ROADWAY & PAVEMENT MARKING PLAN
HANA HIGHWAY RESURFACING
Hookipa Park to Kaupakalua Road
Project No. 36BC-02-17M
Scale: 1" = 40' Date: December, 2016
SHEET No. 7 OF 19 SHEETS

HANA HIGHWAY RESURFACING
Hookipa Park to Kaupakalua Road
Project No. 36BC-02-17M

SHEET No. 13 OF 19 SHEETS

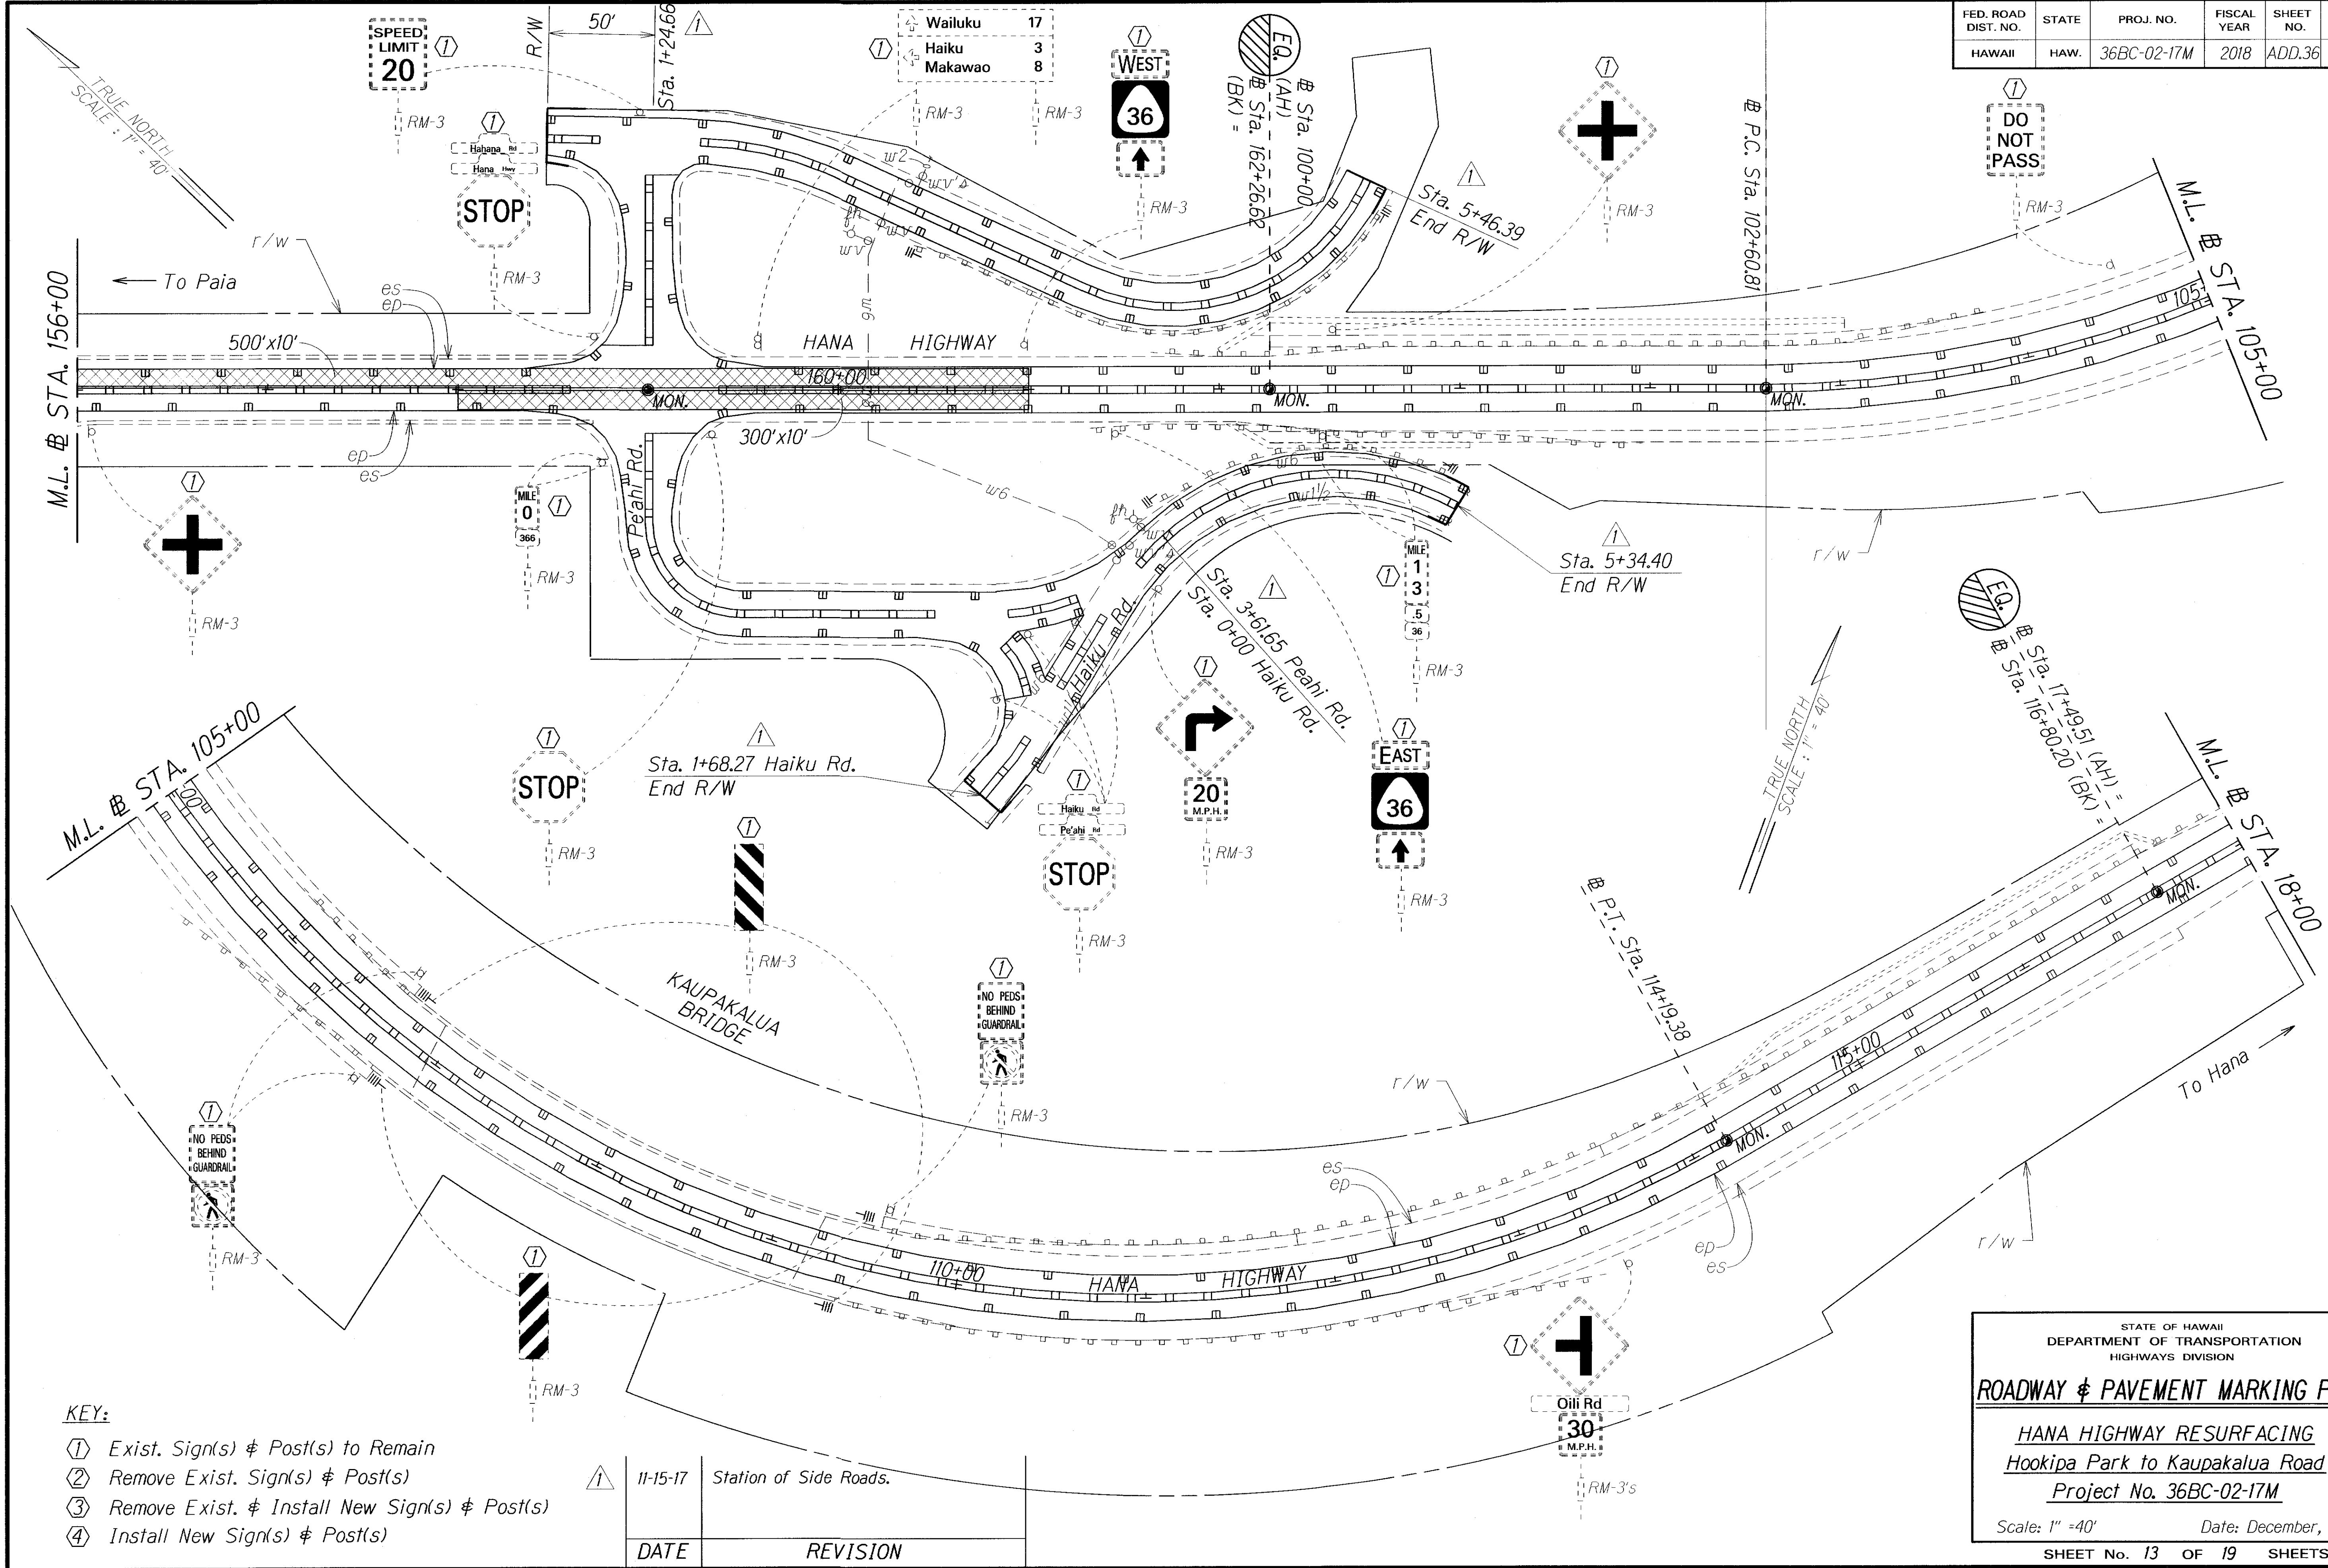
① 11-15-17 Station of Side Roads.
